KV(-B) Series Villa Door Station Firmware **V2.2.53** 221229 Release Note (2023-01-19)

Device Model	DS-KV6103-PE1(B)、DS-KV6113-PE1(B)、DS-KV6113-WPE1(B)、DS-KV8113-WME1(B)、DS-KV8213-WME1(B)、DS-KV8413-WME1(B)
Firmware Version	V2.2.53_221229
iVMS-4200 Version	Latest version
Hik-Connect APP	Latest version

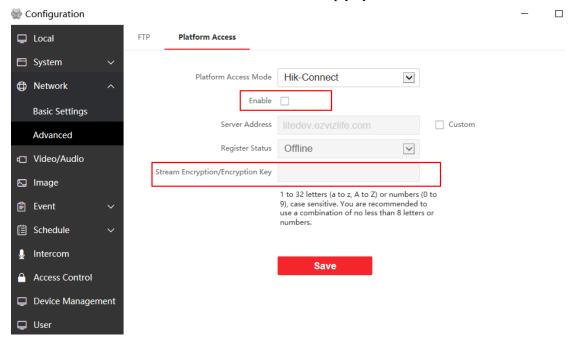
1. HiK-Connect is disabled and Verification code is empty by default.

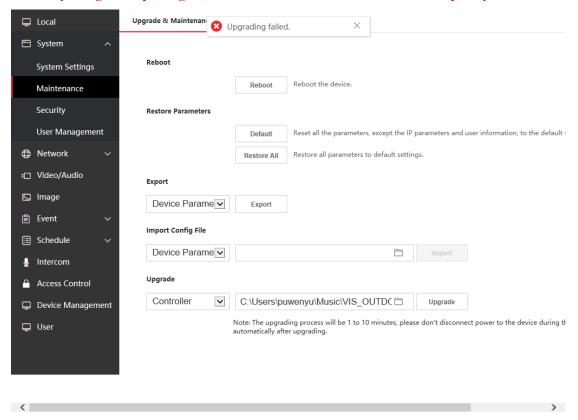
1. Since V2.2.50_210630, remote degradation of devices is not supported in all subsequent versions. When degradation occurs, it will prompt Upgrading failed.

Notice: Although the device can be degraded by serial port, the device will fail to start and cannot change the version by using serial port again, which means that the device will be completely unusable.

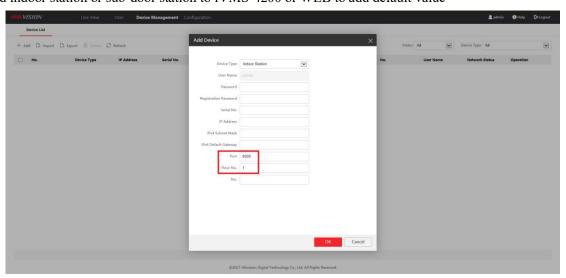
1. The changed name of the door station will be displayed on the call interface or live view interface of the indoor station

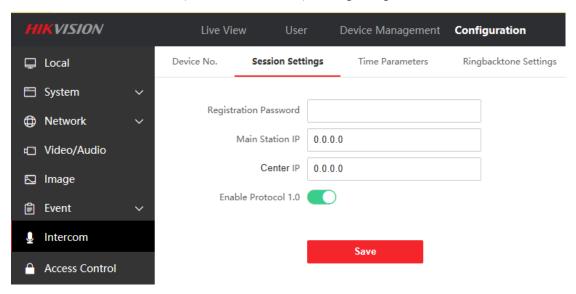
2. Add indoor station or sub-door station to iVMS-4200 or WEB to add default value

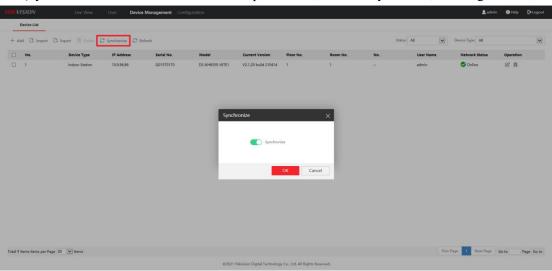
1. Change the Regist Password to the Registration Password in the export excel

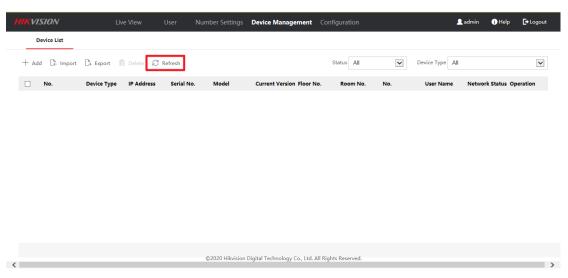
1. New refresh button is used to refresh the status of added devices

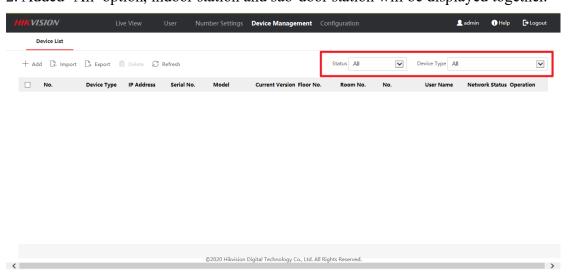
2. Added 'All' option, indoor station and sub-door station will be displayed together.

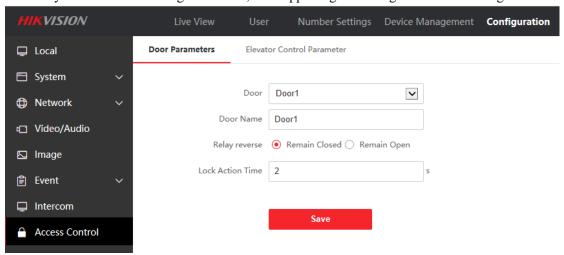
1. Modify the default unlocking time to 2 s, and supporting unlocking time can be configured with 1-255 s

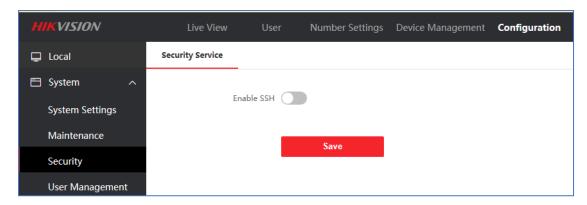
2. The default position of the OSD is adjusted to the lower right corner. When performing intercom with the master station and indoor station, the default OSD will not block the existing key information;

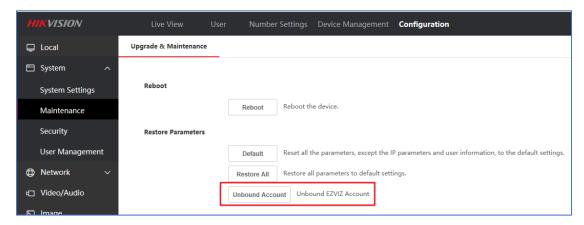
3. The user can remotely open the device SSH function through the WEB;

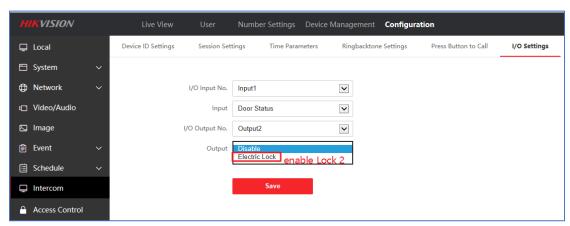
4. Support to actively unbind Hik-Connect account through WEB configuration
